**ASHLAND PLANNING DEPARTMENT
PRE-APPLICATION CONFERENCE
COMMENT SHEET**

December 8, 2021

SITE: 710 Ashland Creek
APPLICANT: Verity Construction
REQUEST: Physical & Environmental Constraints Review Permit for Hillside Development

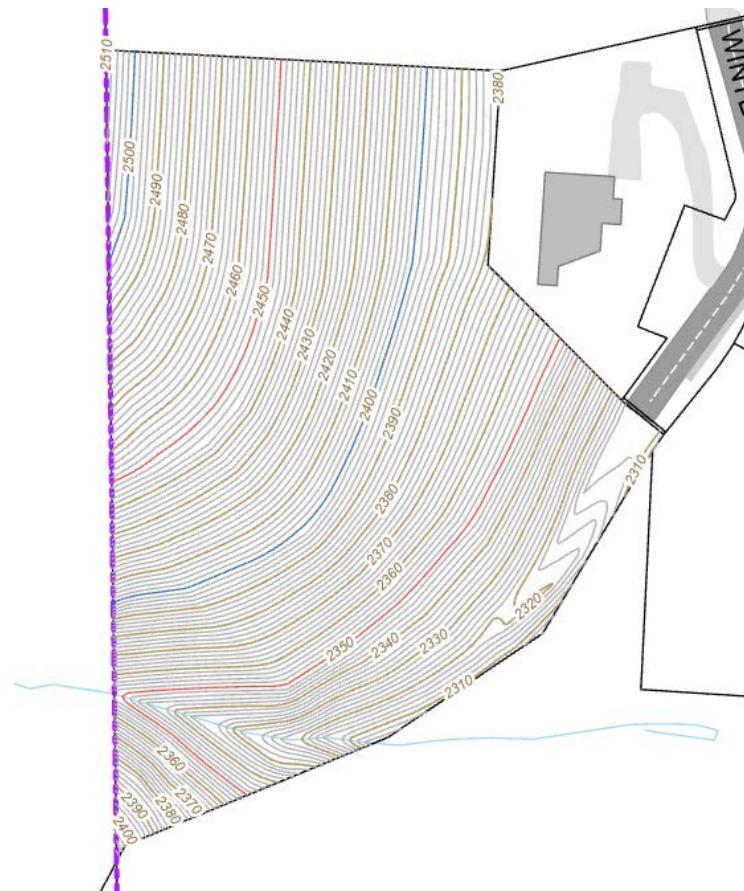
The property located at 710 Ashland Creek is a steeply sloped lot. Virtually the entire lot is ‘severely constrained’ (slopes greater than 35%). On the image below (generated by City GIS) the dark magenta are slopes greater than 35% (typically there is light magenta showing slopes greater than 25%, however this entire lot has an average steepness of 55% - discussed further below).

Development Standards for Wildfire Lands (AMC 18.3.10.100)

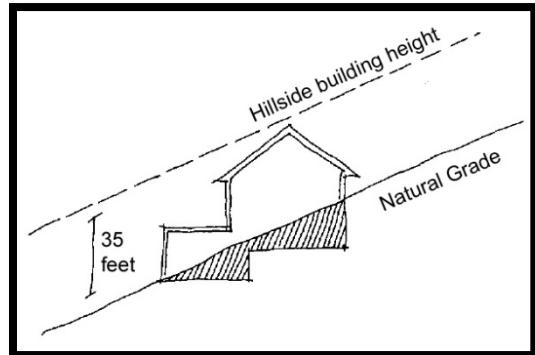
The property is located within the designated Wildfire Lands Overlay. As a result, a Fire Prevention and Control Plan, prepared at the same scale as the development plans, addressing the General Fuel Modification Area requirements in AMC 18.3.10.100.B is required with the application. Additionally, any new landscaping proposed is required to meet the General Fuel Modification Area standards and not include plants listed on the Prohibited Flammable Plant List per Resolution 2018-028.
